SCOPE 2.0: A model to simulate vegetated land surface fluxes and satellite signals

Response to reviewers' comments

*Peiqi Yang, Egor Prikaziuk, Wout Verhoef, Christiaan van der Tol**

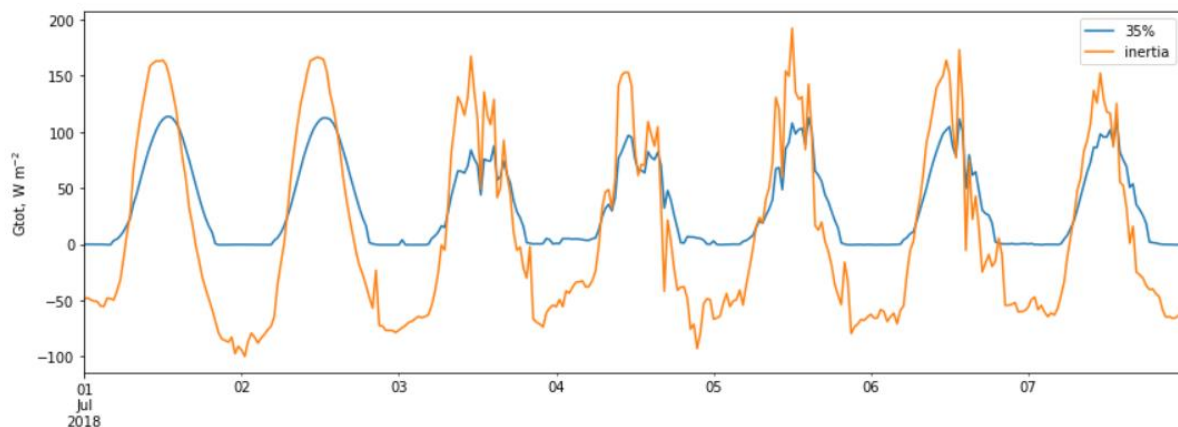
1. While the improved algorithms are well described, the performance/effects of the new algorithms are not fully demonstrated.

(1) Can you compare TOC reflectance, GPP and SIF between using a vertically variant C_{ab} and using an invariant C_{ab} ? This is very interesting as I see many studies, including ESA's products, interpret canopy chlorophyll content as the product of LAI and C_{ab} without considering the vertical variation of C_{ab} . SCOPE 2.0 can help us understand this impact.

Response: We agree with the reviewer on the importance of vertical variation of leaf biophysical properties. Although the specific experiment/comparison is not included in this manuscript, we have already done this in the other paper about the mSCOPE model, which is a branch of the SCOPE model that includes vertical heterogeneity. In that work, we show the effects of vertical profiles of C_{ab} on TOC reflectance, GPP, SIF and light use efficiency. To avoid repetition, we decided not to include such comparison in this manuscript, but added sentences clearly stating the comparison is available in the mSCOPE paper.

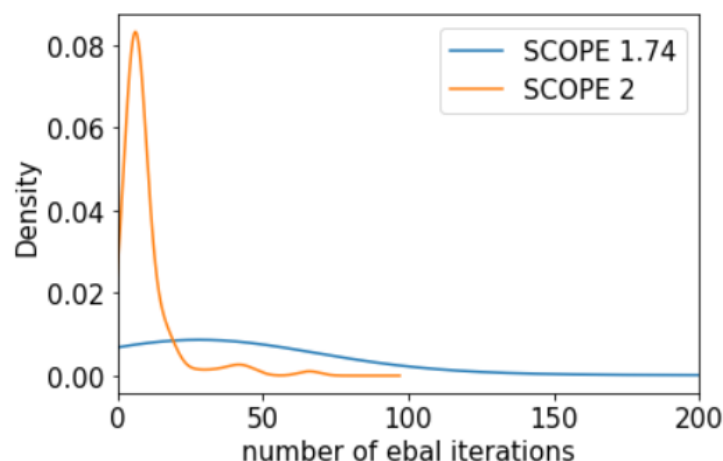
(3) Can you use figures/tables to show

1) how energy balance closure is improved by using the new iteration algorithm,

Response: The older version 1.74 requires on average 59 iterations to close the energy balance, the 2.0 version requires on average 9. Furthermore, the standard deviations are dramatically different 59 ± 92 vs 9 ± 9 .
